FOXCONN		HON HAI Precision Ind. Co., Ltd. CCPBG - R&D Division	
Title		History (MS/SD)	
Size	Document Number	Rev	
A3	V030 MP	1.1	
Date:	Thursday, January 20, 2011	Sheet	14 of 15

MS/SD DB

KB&BL Conn

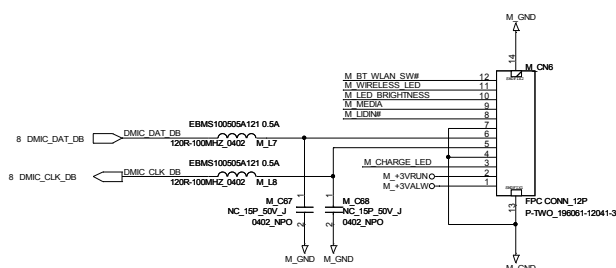
2010.1013(DVT)
For ME request
M_CN8 change from
1N-0010009-FXG0 to
1N-001000A-FXG0

2010.1128(PVT)
For SI overload test fail
add M_F4

2011.0105
For M_F4 broken issue
M_CN4 pin11 GND change to NC

KBC Conn

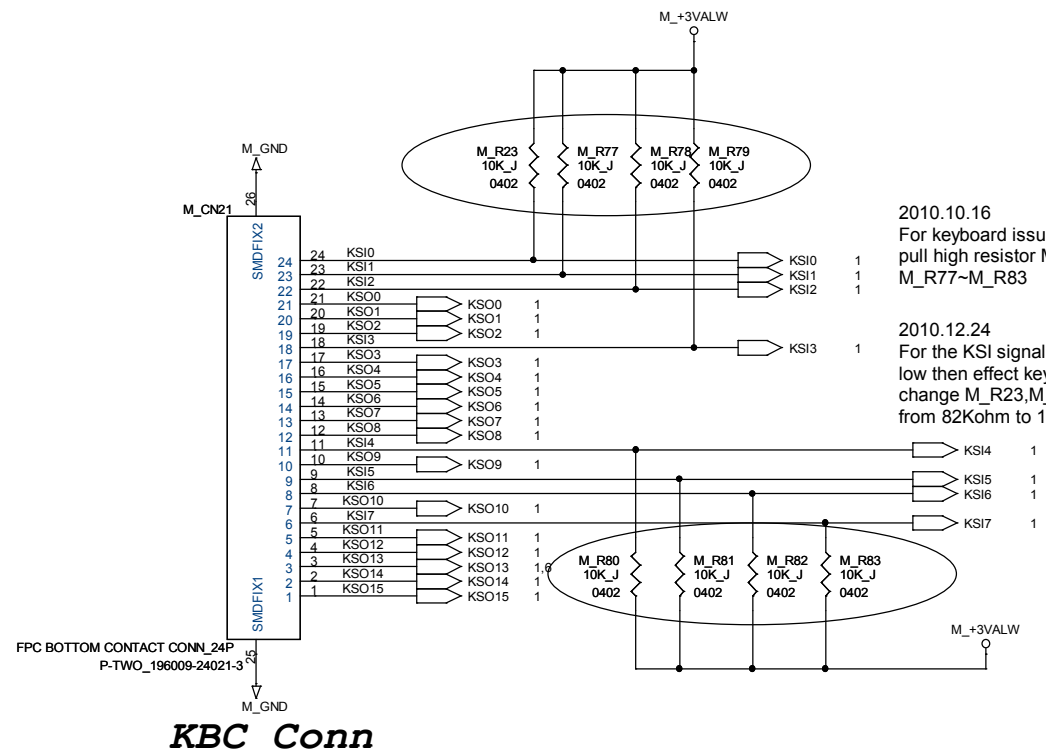
2010.10.16
For keyboard issue add KSIX
pull high resistor M_R23
M_R77~M_R83

2010.12.24
For the KSI signal voltage is too
low then effect keyboard function
change M_R23,M_R77~M_R83
from 82Kohm to 10Kohm

Backlit Power Conn

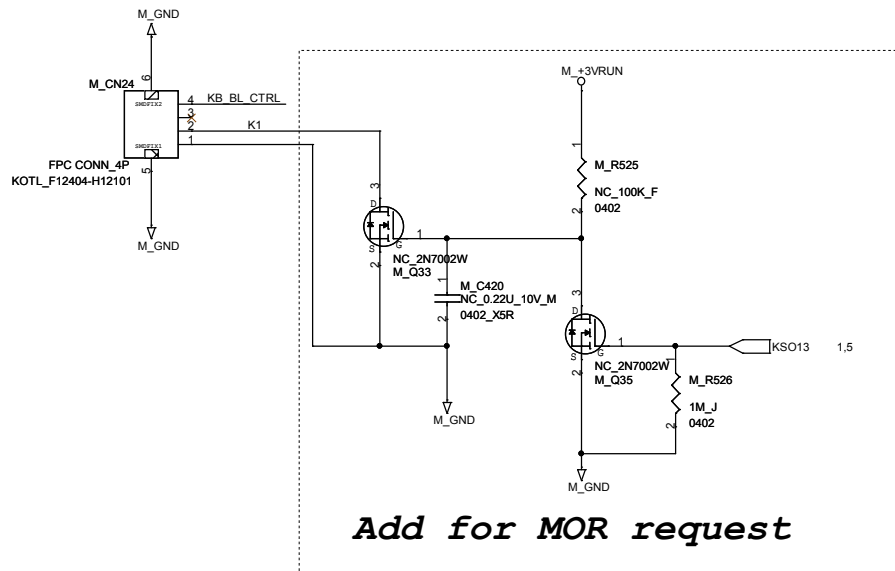
Add for MOR request

01/20: Keyboard backlight function of HW circuit no need,
So delete M_R525,M_C420,M_Q33,M_Q35

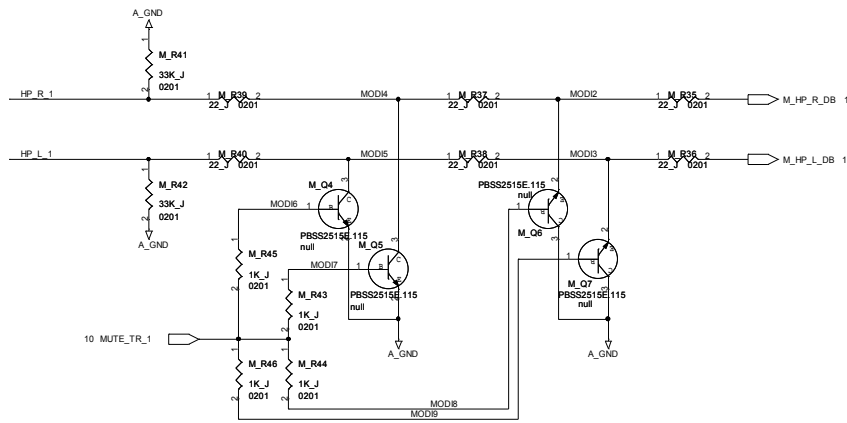
2010.09.20(DVT)
For the speaker load test fail
change M_Q9 from 17-ME2306A-0000 to 17-ME2306D-0000

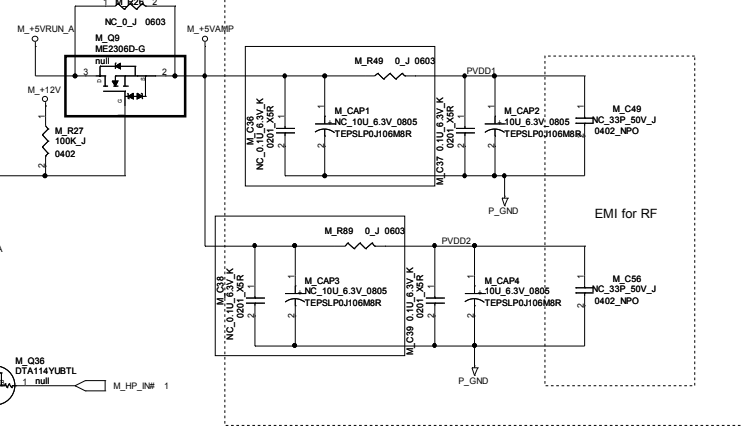
2010.12.24
When delete M_C36, M_C38, M_CAP1, M_CAP3 and change M_L5, M_L6 from 1L-BHCB061-2100 to 1R-0000000-J300, the audio quality is OK

HW THERMAL PROTECTION

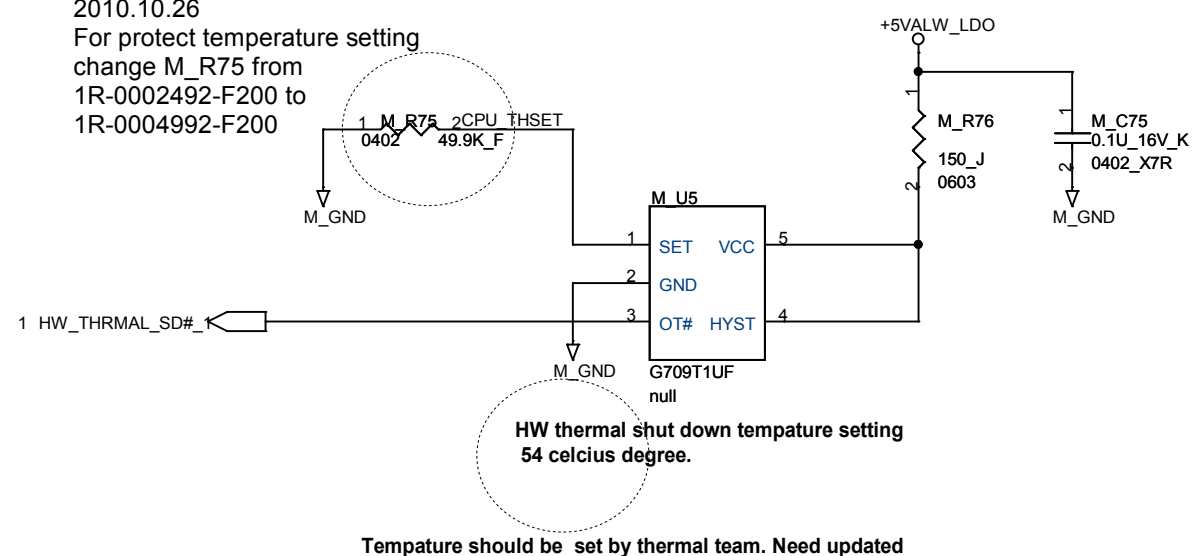
For protect temperature setting
change M_R75 from
1R-0002492-F200 to
1R-0004992-F200

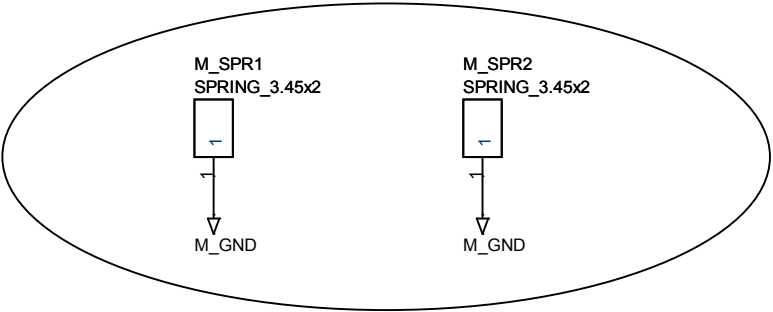
2010.10.18
Add for EMI request
